URGENT: RECALL INFORMATION
Bariatric Bed Correction

Component Numbers: BAR5490, BAR5490IVC

Model Numbers: BAR600, BAR600IVC, BARPKGCA, BARPKG, BARPKGIVC-1633

September 19, 2011

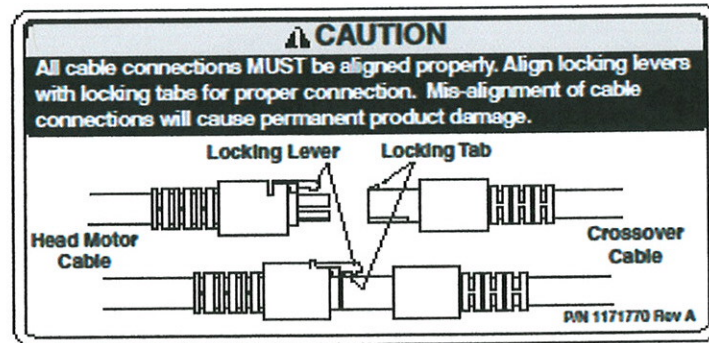
Until that time, review the issue with your installation technicians or quarantine disassembled product. This review with your technicians must include the fact that the connector is keyed, is meant to connect only one way and must not be forced or deformed during connection.

The warning label shown below is for education of your delivery technicians and this warning label is also found on the side frame of the bed.
